September 7, 1989

We have reviewed the document entitled Work Plan for an Expanded Site Assessment at the Mixed Waste Landfill, received July 31, 1989. We have enclosed comments for your consideration. If you have any questions concerning our comments, please call me or your staff may call Bill Gallagher of my staff at (FTS) 255-6775.

## COMMENTS ON SANDIA NATIONAL LABORATORIES MIXED WASTE LANDFILL INVESTIGATION

# FIGURE 1

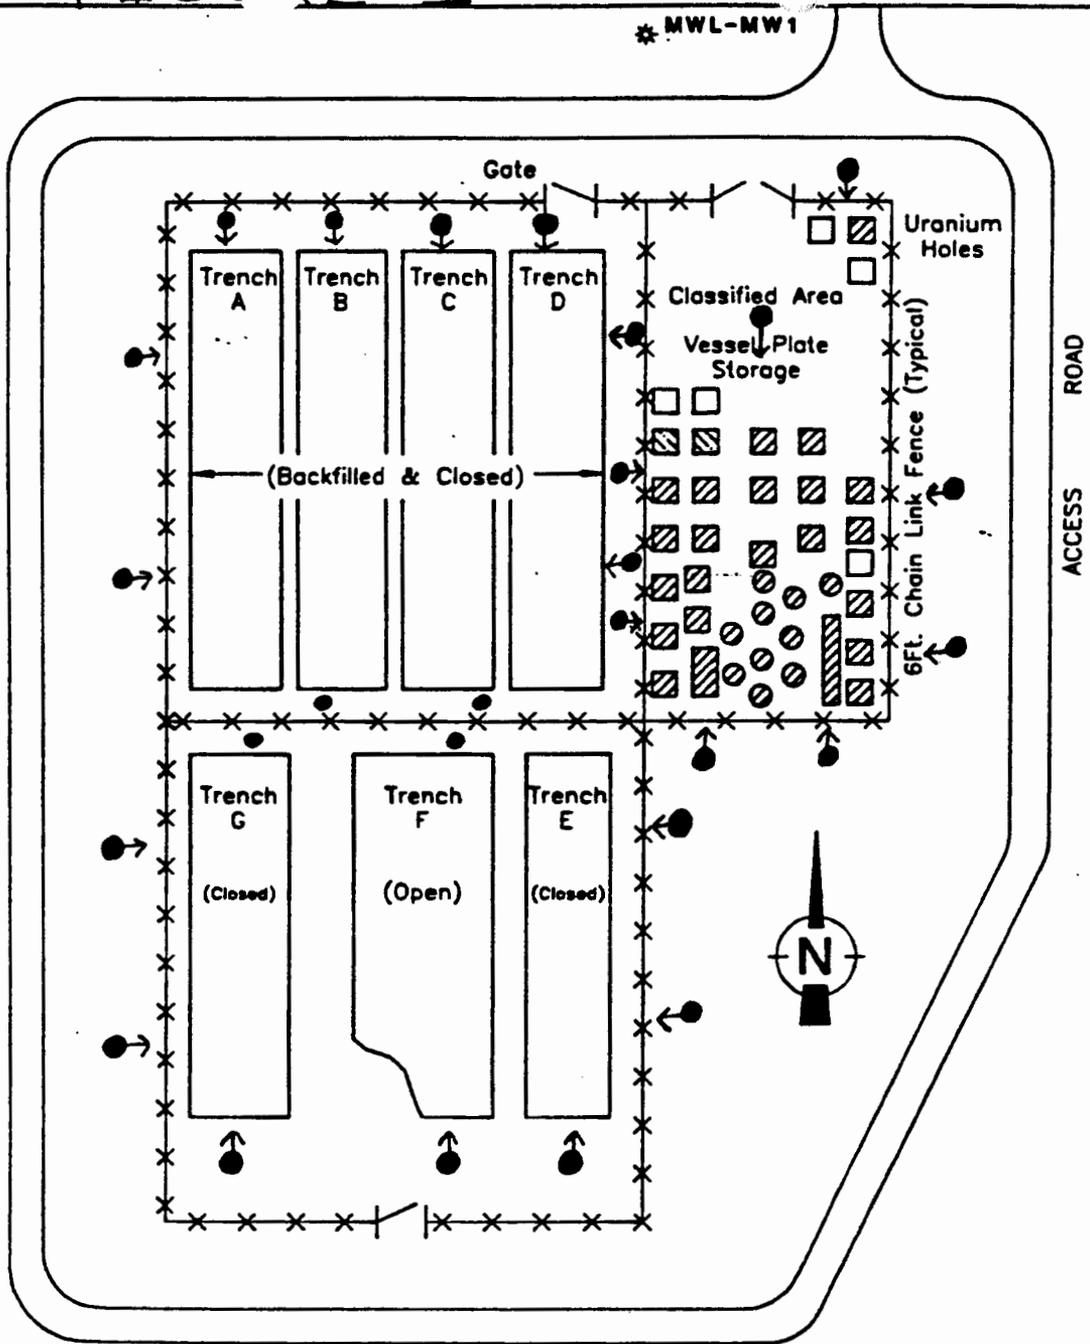
**Page 3-12; Soil Boring Locations:** Since the general lithology of the first 100 feet is comprised of sands and gravels and the soil profile description to 29 feet indicated no significant horizon changes, it is recommended that most (if not all) soil borings should be angled underneath all waste trenches (if physically and mechanically possible). Most of the liquid phase of the contaminants should migrate vertically downward, with a minimum horizontal component. These borings should also pick up lateral gas originating from the trenches. Also, due to the high probability of flow front being non-uniform or discontinuous (appeared to be the case in the chromic acid pits), slant drilling would more likely pick up contamination. Recommended locations for borings are shown on Figure 1 (these locations assume that no preliminary soil-gas or lithologic surveys were performed).

**GENERAL COMMENT:** It should be noted that this investigation is intended to determine whether there has been a release from the mixed waste landfill. Therefore, the majority of the borings (unless preliminary surveys indicate other locations) should be angled underneath the trenches, the most likely region where a release would be detected. Some vertical borings could be beneficial, especially in the area between trenches GFE and ABCD (See Figure 1). This investigation is considered phase 1, with possibly more investigations to follow, contingent on the results of the phase 1 investigation.

Figure 2

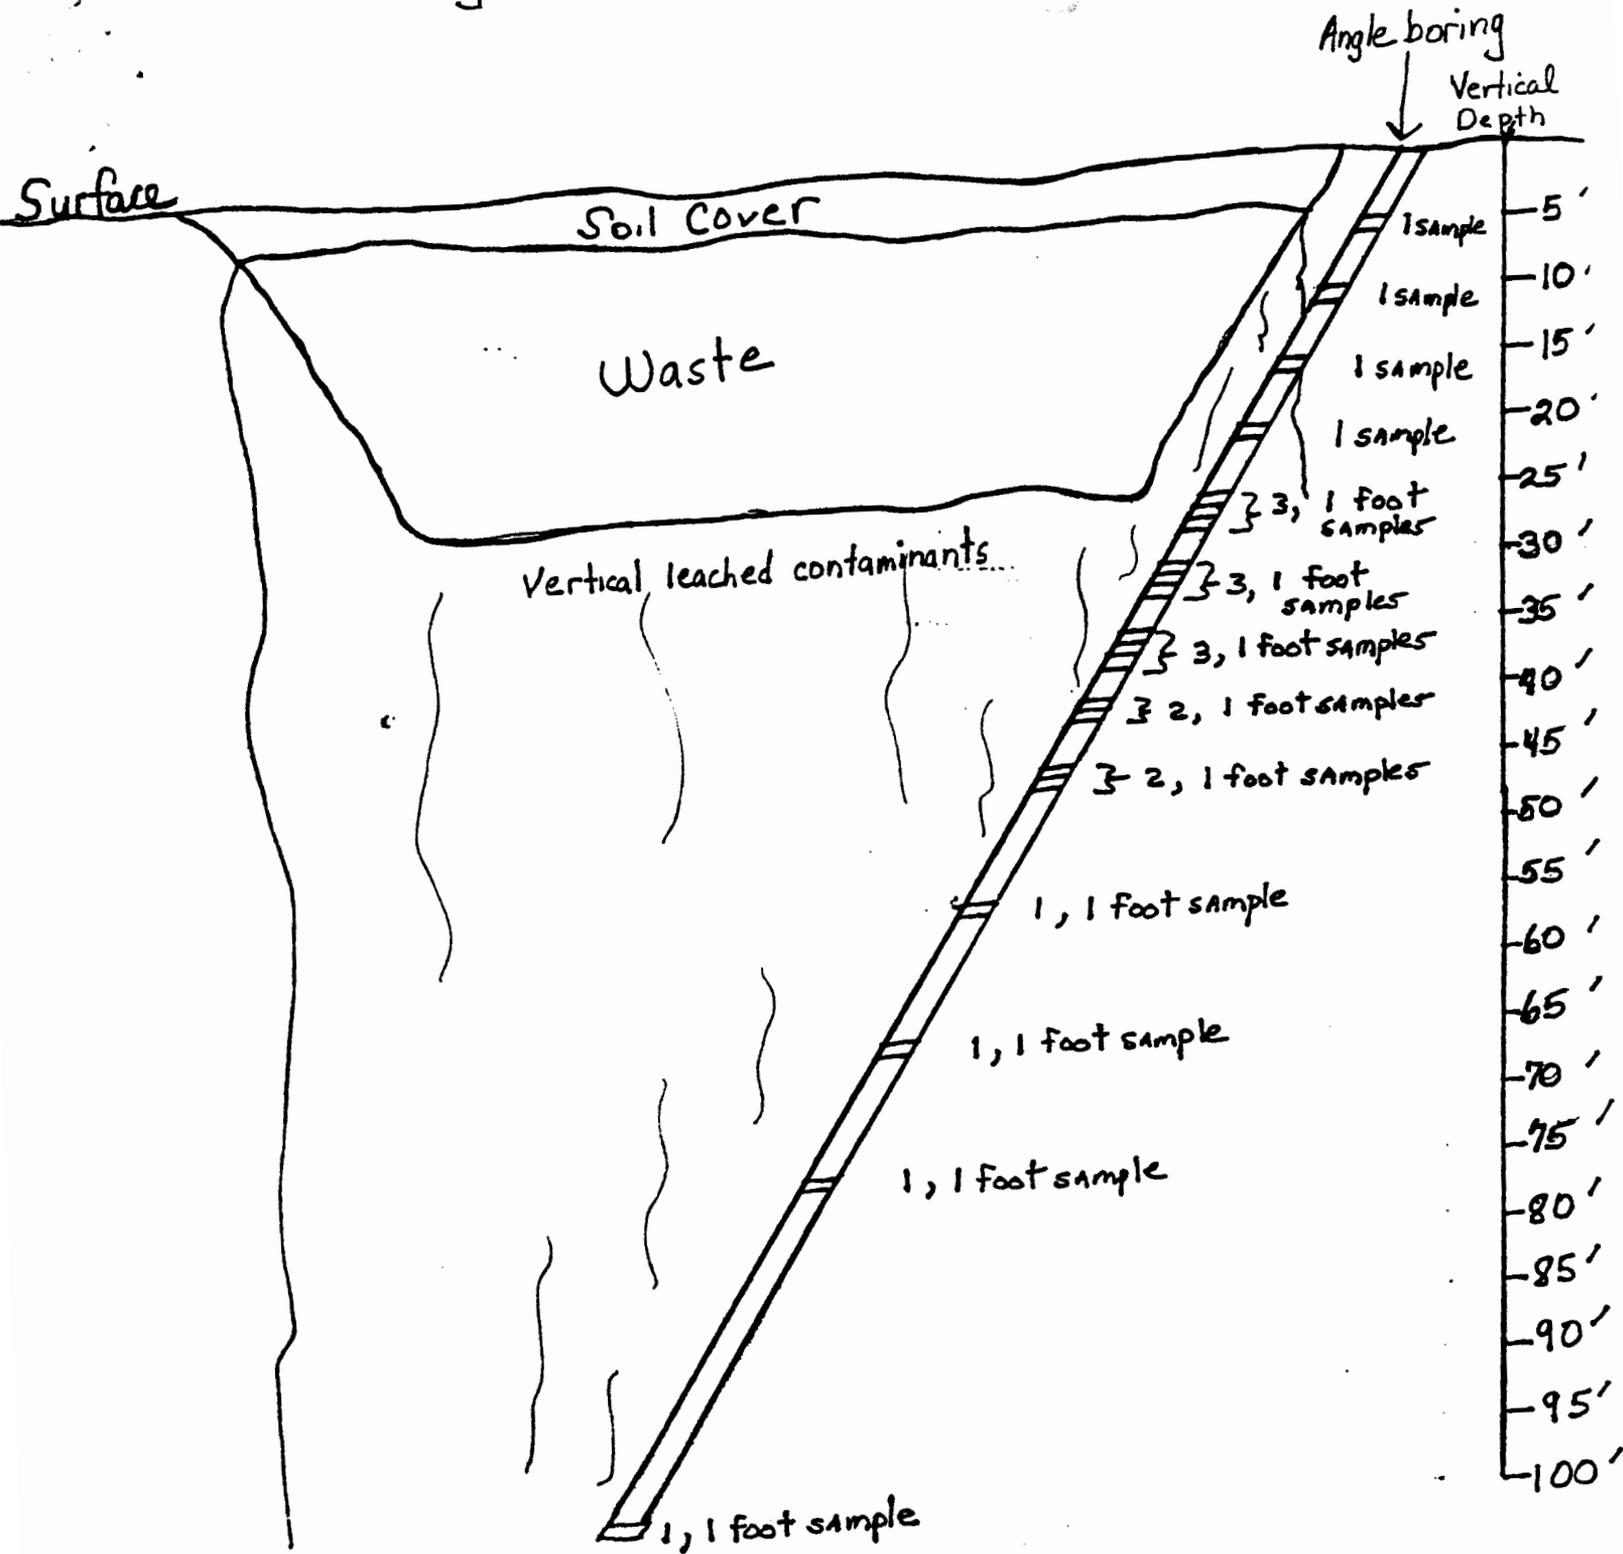
**Page 3-15; Sampling Collection:** During each 5 foot sampling interval, the core should be visually and soil-gas screened for contamination. If contamination is found by those screening methods, then sampling of the contaminated layers should occur, regardless of the previously pre-planned sampling intervals. Also a soil-gas reading should be done down the hole after each 5 or 10 foot sampling interval. Sampling intervals for chemical analysis should be no more than 1 foot, so that dilution of the sample will not occur. There should be no compositing of samples for chemical analysis. Most of the samples should concentrate on the zone immediately beneath the trenches (usually 25 feet) to approximately 75 feet. Figure 2 shows this sampling concept, including the discrete sampling intervals.

Each boring to 100 feet should include 21 individual sampling intervals, with 150 foot samples subject to Sandia discretion
